From: Hughes, Jane <Jane.Hughes@wiltshire.gov.uk>
Sent: Thursday, February 1, 2024 4:57 PM
To: James, Jonathan <Jonathan.James@wiltshire.gov.uk>
Subject: RE: (BROM37) Site of former Bromham Social Centre New Road, Bromham, Wilts : Consultation - PL/2023/10811

Fig 1. Approx location of BROM37.

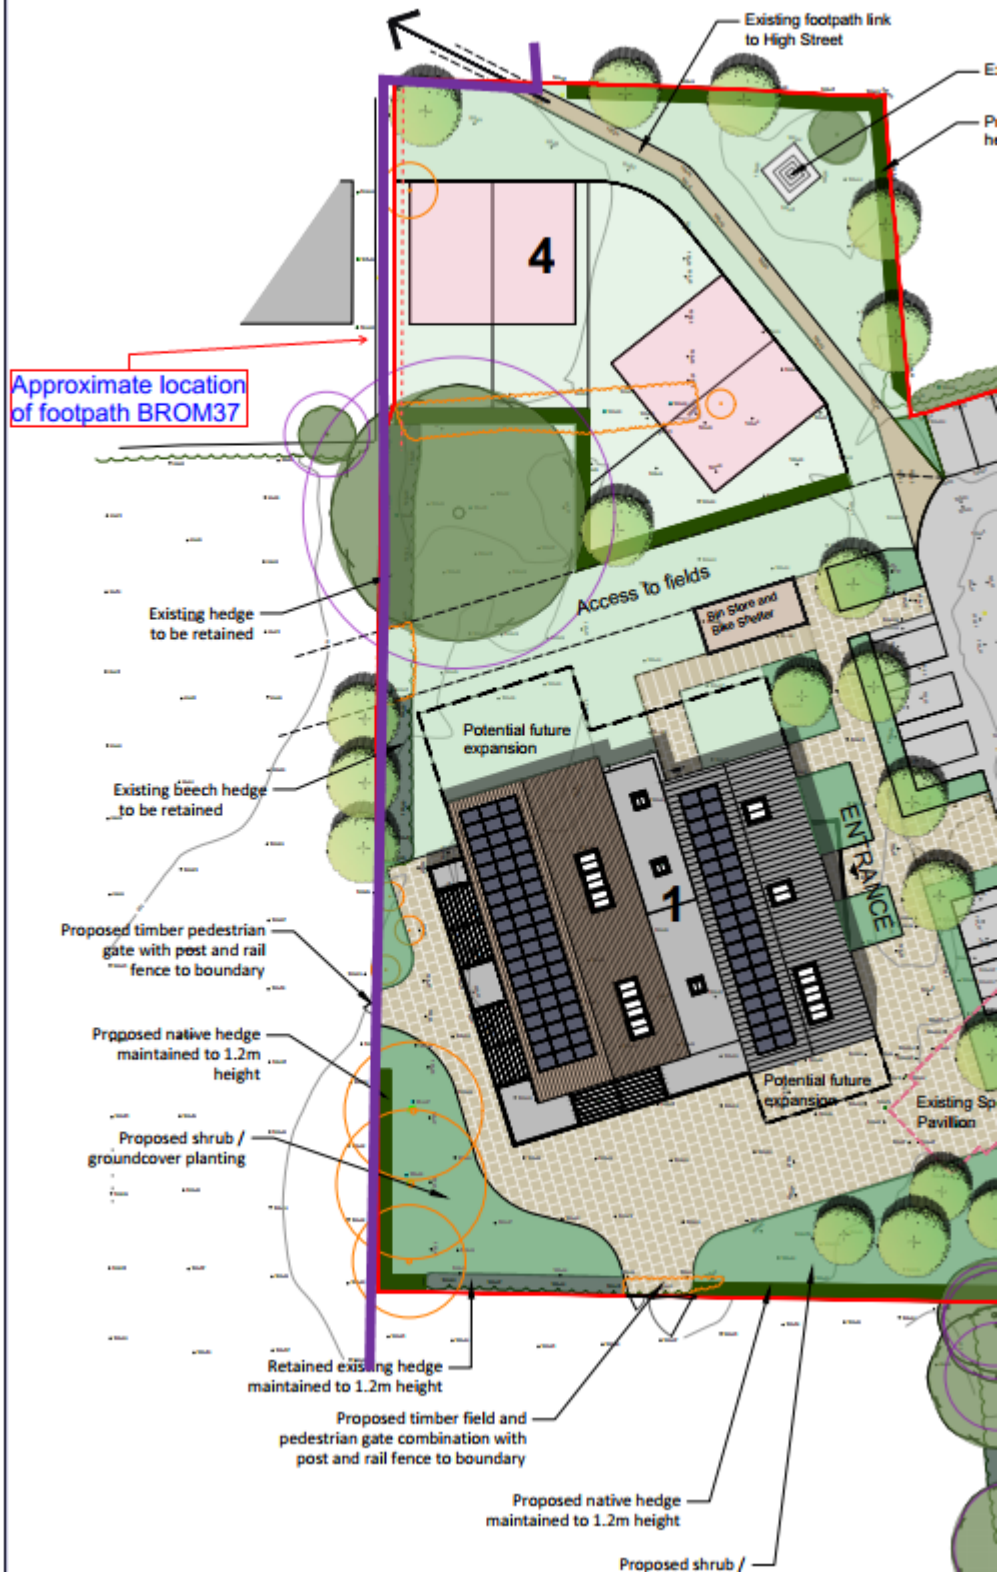
I would like to object to the application based on the effect on the footpath, BROM37 which abuts the north and west boundary of the site. It is shown approximately in purple on the extract from the landscape concept plan. Fig 1 below.

I would like the applicant to provide additional information and to make improvements to the footpath. They should provide a photographic survey of the existing footpath BROM37 where it abuts the site. I would like to see the enclosed section of BROM37 widened to a minimum of 2 metres where it abuts the north and western boundary of the site adjacent to one of the proposed new properties. The widened section should be surfaced to match the rest of the path. Any fencing alongside the path in this location should be a maximum of 1.2 metres high. Any hedges encroaching onto the width of the path should be cut back and the specimen trees should be moved to ensure they are not creating an obstruction.

Fig 2. Location of possible narrowing of footpath.

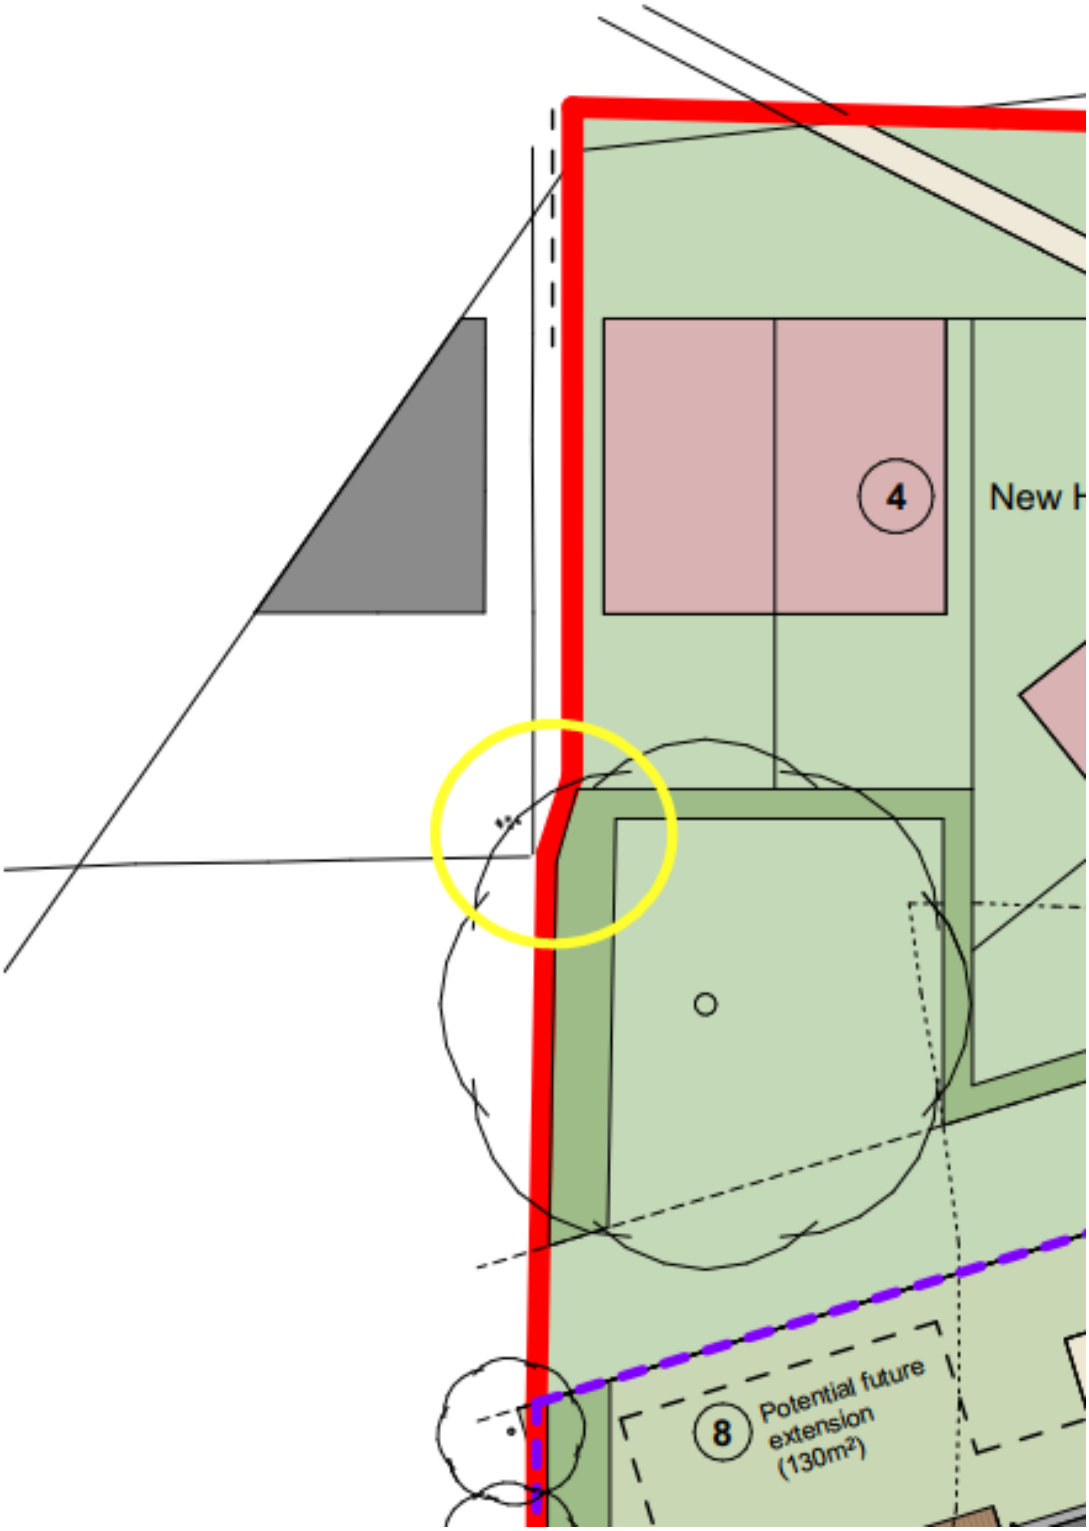
BROM37 runs along part of the northern site boundary along an enclosed path adjacent to the existing play area. It then turns south along the western boundary of the site following an enclosed section of path adjacent to the play area before entering the field. It runs through the field adjacent to the hedge. The applicant states that the footpath is outside of the boundary of the site and will be unaffected by the proposals. Proposed developments should enhance and protect existing public rights of way. Our policy is to avoid creating narrow enclosed footpaths and to make improvements to existing enclosed paths by widening them and improving surfacing where possible. One of the proposed houses is located within 1 to 1.5 metres of the edge of the footpath. This will make the path darker and feel more enclosed. At the rear boundary of the proposed new property the red line site boundary kinks outwards and there is a section of the path here which looks narrower on the plan (circled yellow in Fig 2 below). I have not visited the site so I don't know if this exists as an issue on the ground. There are also proposed specimen trees located next to the existing hedge adjacent to the proposed community hub building which look like they will obstruct the footpath.
